SL 2005-001

ALTERATION OF TANK LEVEL SENSOR CONNECTION

SYSTEM MODEL: 301 FIRE ATTACK SYSTEM.

DESCRIPTION: THIS SERVICE LETTER PROVIDES FOR THE MODIFICATION OF THE EXISTING TANK LEVEL SENSOR WIRING BY REPLACING A CONNECTOR. THIS REPLACEMENT CONNECTOR THEN ALLOWS INSTALLATION OF THE LATEST CONFIGURATION OF LEVEL SENSOR.

Figure 1, Modified Connector

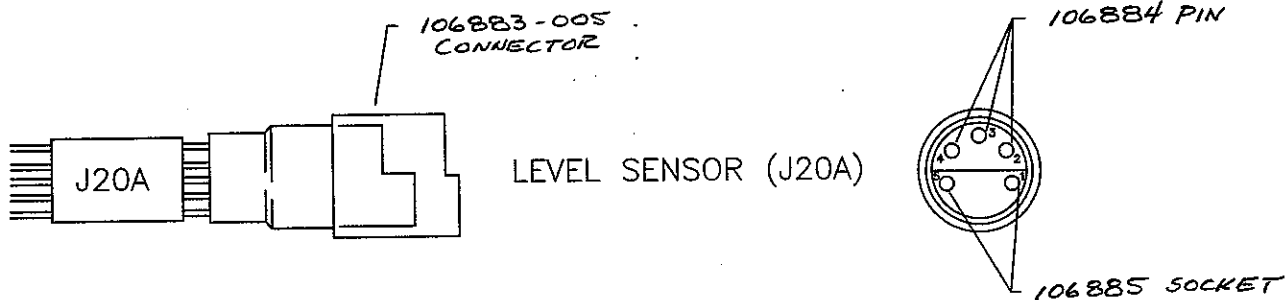
- 6) Crimp or solder replacement pins and sockets onto the appropriate wire as shown in figure 1 below. Use heat gun to shrink labels over the wires next to the hardware.

- 7) Press pins and sockets into their appropriate locations in the rubber connector boot provided (p/n 106883-005) as shown in figure 1 below. Slide large heat shrink tube up over connector end and over plastic harness tubing. Heat shrink in place.
